HILLS OF GOLD WIND FARM

Independent Planning Commission Presentation

January 2024

T53-63 are the highest producing, lowest environmental impact turbines

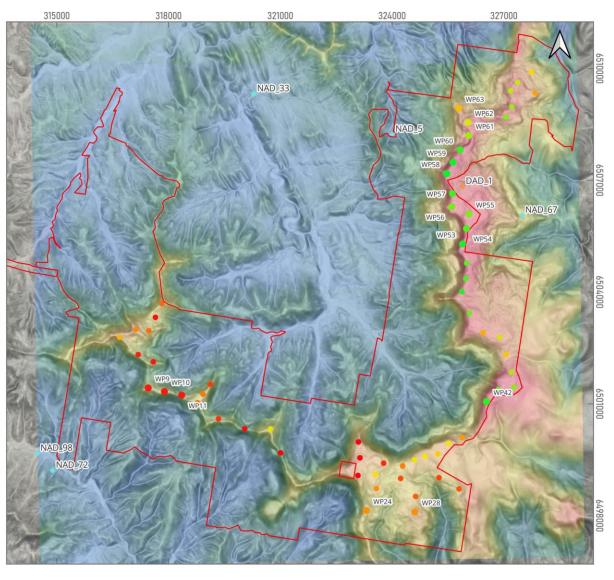
- Geographically Finite
 Opportunity for Feasible
 Infinite Resource
- T53 T63 average 22 % higher than the remaining turbines (and provide power for 38,000 more homes per annum)
- T53-T63 are on flat areas of mostly exotic pasture
- Reduces cost of energy
- Increases feasible generation volume

DPHI Assessment Review Hanging Rock Cluster – NAD 67

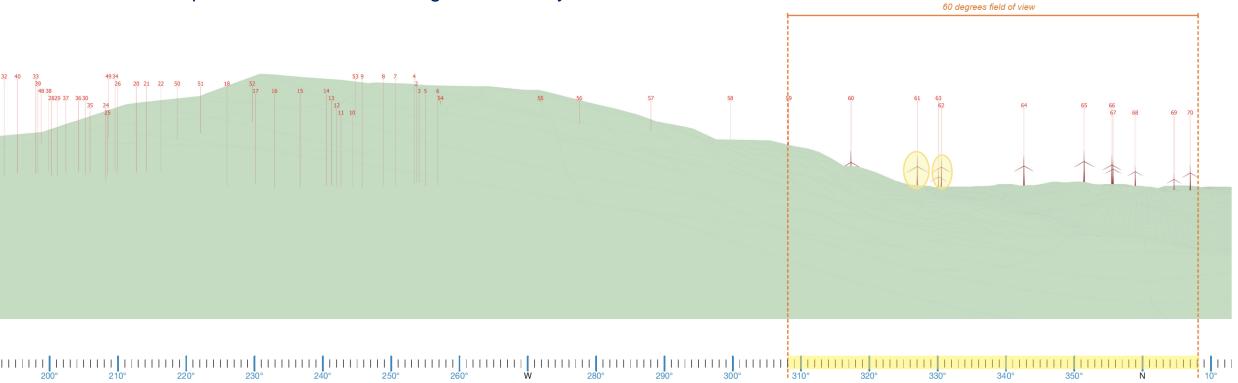
- No access granted to undertake an assessment from NAD 67
- Turbines only visible within one sector
- Low Visual Impact with Visual Screening within 5 7 years

T61 and T62 recommended for removal

DPHI Assessment Review Hanging Rock Cluster – NAD 67

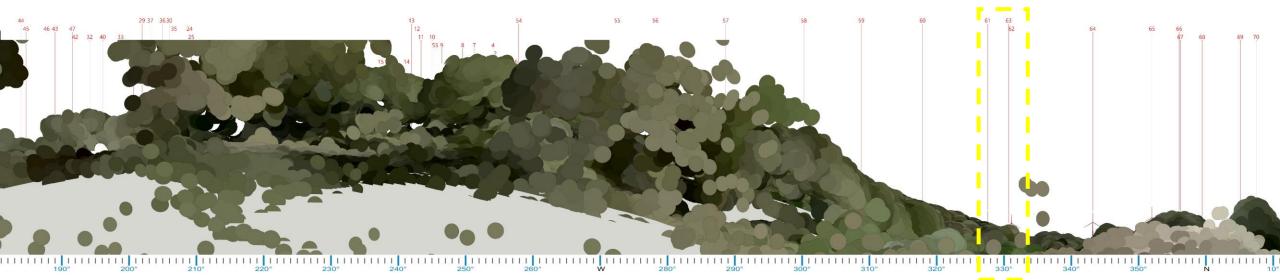
- Revised wireframe produced using LiDAR data
- Demonstrates turbines well screened with existing vegetation and likely effectiveness of further screening
- Turbines don't dominate the landscape

Partially visible turbines proposed for removal

DPHI Assessment Review – Hanging Rock Cluster – NAD 5

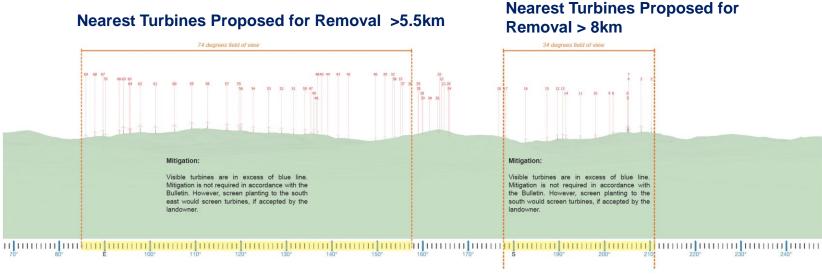
Turbines recommended for removal by DPHI

- Turbines visible within one sector
- Low Visual Impact with Visual Screening within 2 - 5 years (noting error in DPHI Assessment stating 10 years)

Photomontage (above) taken from east side of house, secondary view.

Primary views to the north, house is orientated with outlook over Nundle Creek Valley.

Opportunity to screen views to the project whilst maintaining desirable views.

Dwelling NAD 72

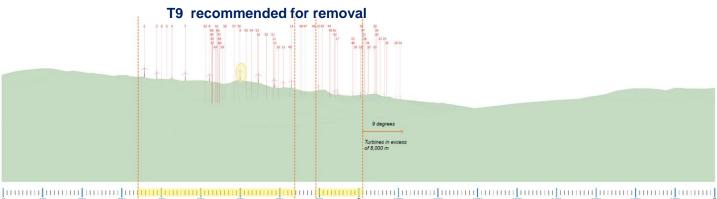
- DPHI state turbines dominate the landscape however visible within 1 x 60 degree sector
- Low Visual Impact with Visual Screening within 7 - 10 years
- Nearest turbine is 3.4km in excess of black line

T9, 10 & T11 recommended for removal
